ADDENDUM 31 January 2024

Weld Road Reserve Coastal Shared Pathway and Swing Bridge LVEA

From: Renee Davies, landscape architect.

1.0 Further to the Section 92 request from Taranaki Regional Council and feedback from the New Plymouth District Council and associated LVEA peer review undertaken by Richard Bain, the following provides additional information, clarifications and amendments to the LVEA.

Table 1 – Visual Effects Summary

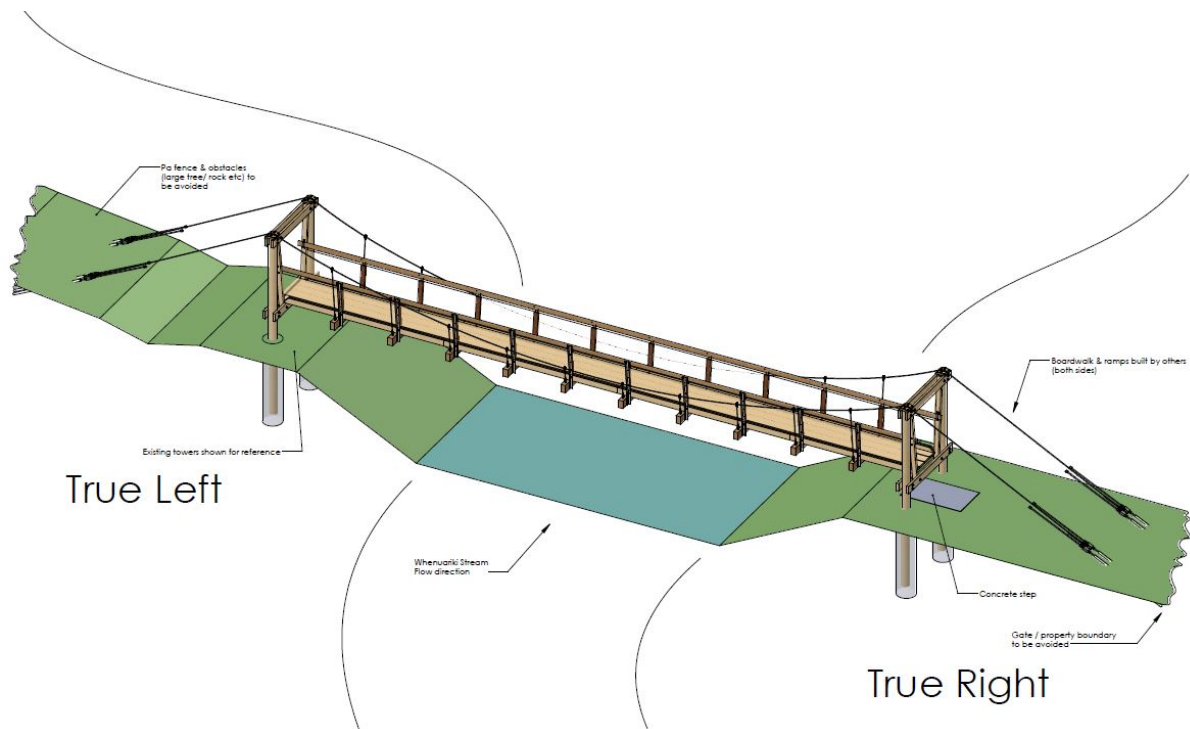
In summary the landscape effects assessment remains at moderate, but the visual effects assessment has been updated to reflect that depending on whether the assessment is considering the bridge or the shared pathway, the degree of visual effect for different viewing audiences is different. The updated visual effects summary is provided below. Please note also that the visual effects summary recognises that during construction effects will be temporarily increased due to the required machinery to be located within the beach zone during construction/placement of the rocks in particular.

The visual effects for the proposal range in the medium to long term (after construction) from very low to moderate. For the different viewing audiences, there are two that sit at moderate effects with the remaining three being very low, low-moderate or low. As the viewing audiences and proposed component of the proposal (whether bridge or shared pathway) are quite different, there is no overall visual effect that summarises in totality.
